**Stantec Consulting Services Inc.**  
12080 Corporate Parkway, Suite 200  
Mequon WI 53092-2661

December 2, 2022  
File: 193707141

**Reference: Response to Request for Additional Information #2; Materials Management Plan and Ch. NR 718 Exemption Request for C. Reiss Coal Dock Property, Superior, Wisconsin, BRRTS Case No. 02-16-589248**

GROUNDWATER CROSS SECTION DETAIL

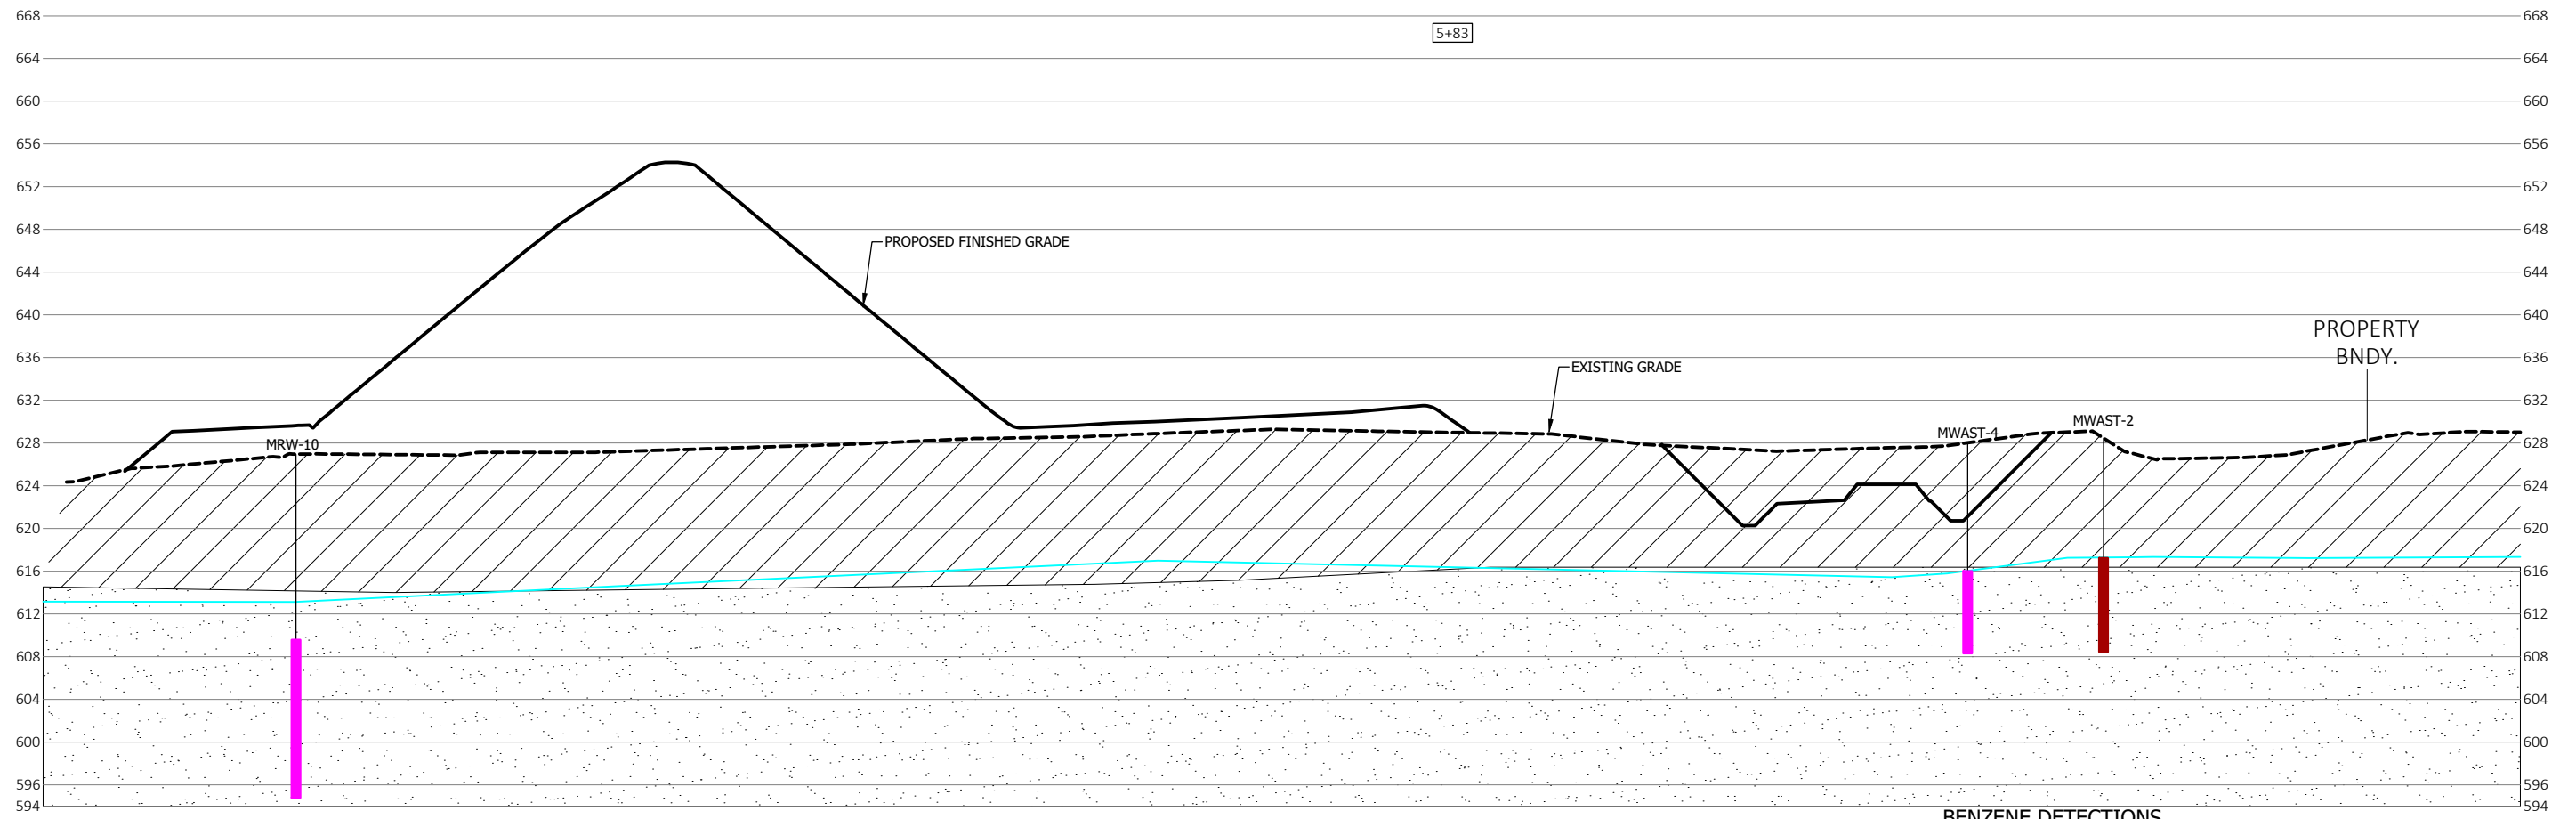
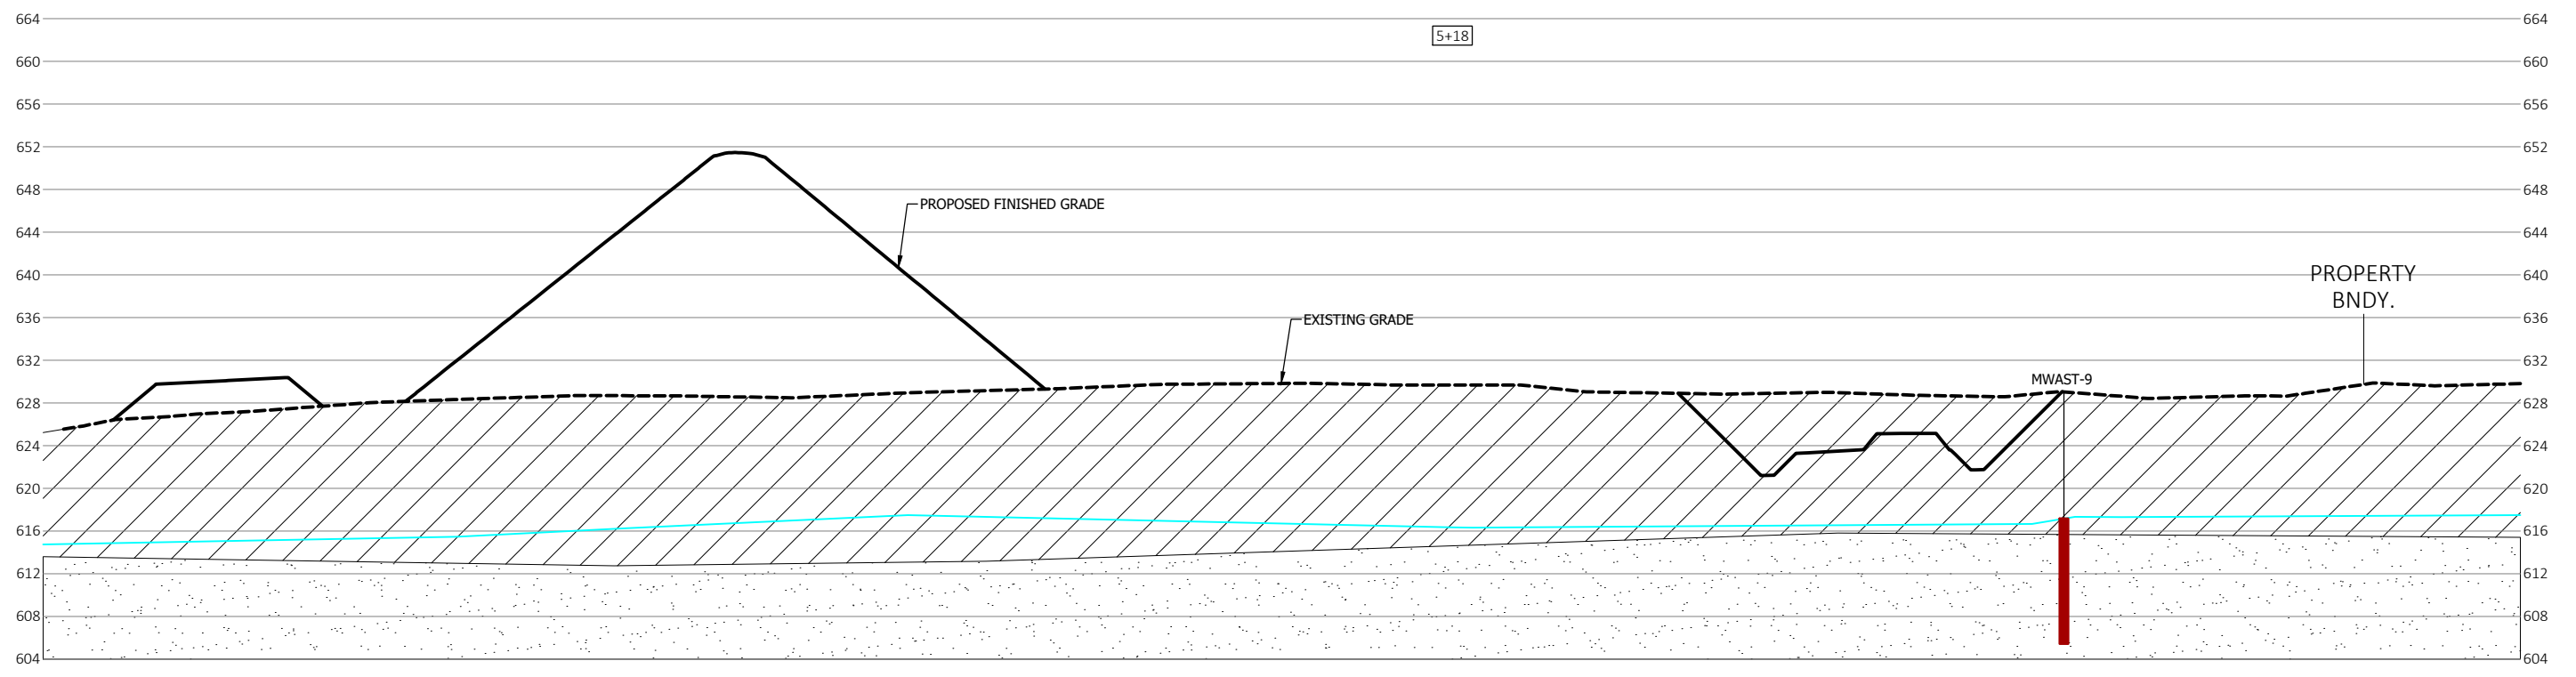
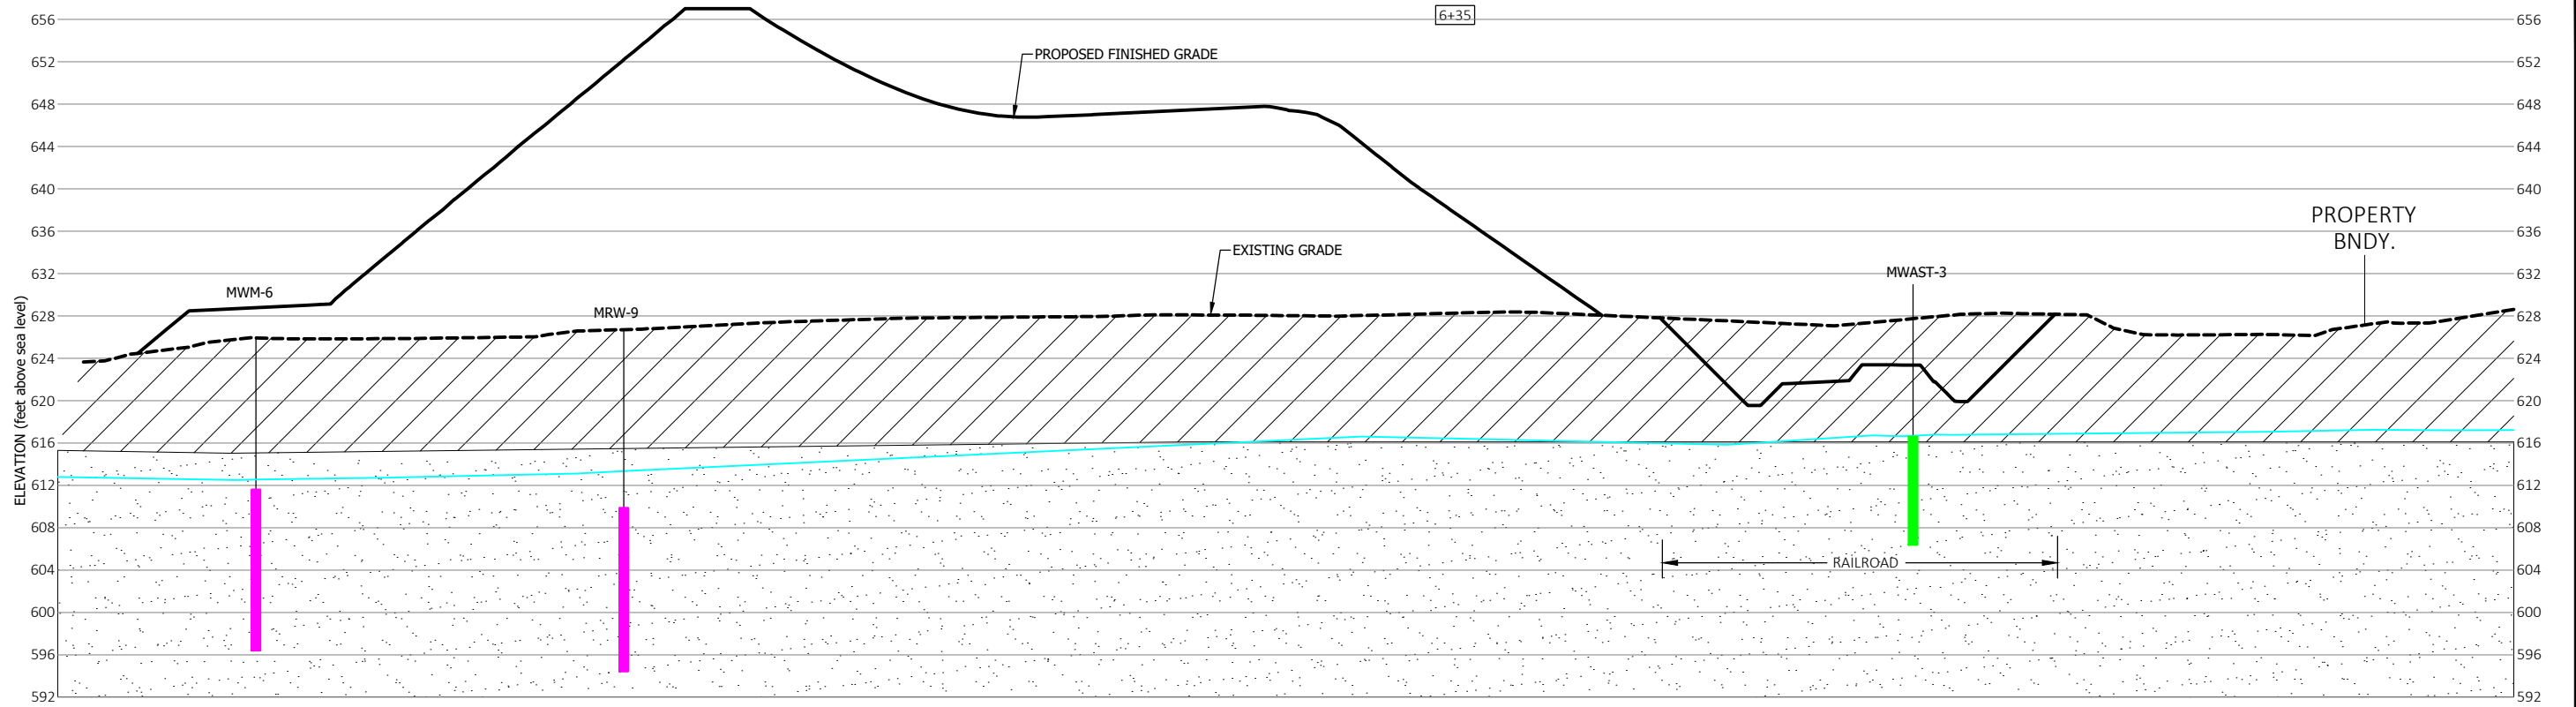
**2. The RR grade and stormwater pond call for excavating site soils, extending into the confining clay layer, and potentially breaching the clay layer. This, combined with the placement of large volumes of soil and sediment adjacent to these excavated areas, could impact the hydrogeologic conditions at the site. There needs to be an evaluation of both the geotechnical and hydrogeological aspects of the proposed excavation and placement of material. To what extent will the proposed activities impact groundwater conditions, including the migration of contaminated groundwater and LNAPL? Do you anticipate the potential migration of contaminated groundwater and LNAPL to the surface in excavated areas? In what other ways will site hydrogeological conditions be impacted by the proposed placement and excavation of material?**

**3. Contaminated groundwater and LNAPL on the adjacent property to the east are not shown in figures 7 & 8.**

**Clay unit.** The cross sections provided on **Figure 8** have been updated to illustrate the approximate depth/thickness of the clay unit present across the Property and depth of the underlying sand/silty sand based on available lithologic information collected by Stantec and others (AET, Antea Group

[Antea] to date. As illustrated on **Figure 8**, the maximum depth of cut is above the clay/sand interface for the majority of proposed Property redevelopment. The only areas where the proposed excavations will breach the clay unit and extend approximately 1 to 1.5 feet into the underlying sand/silty sand are at Stations 11+75 and 15+10. This area is far north of the LNAPL finger plume, and west of the smaller LNAPL plumes on the east-adjointing Property which (as discussed above) are limited in nature and not anticipated to impact proposed property excavations. Therefore, no mobilization of LNAPL or contaminated groundwater is anticipated as part of proposed Property excavations.

**Response:** **Figures 7 and 8** have now been updated to include available groundwater and LNAPL information on the parcels adjacent to the Property (including the east-adjointing property) and are included as attachments to this submittal.

As discussed in Response #2, LIF data available for the Property in areas near the smaller LNAPL plumes present along the east-adjointing property (north of the “finger plume”) have also been added to **Figures 7 and 8** to illustrate that LNAPL impacts from these smaller plumes are limited in nature and are not anticipated to impact Property construction.
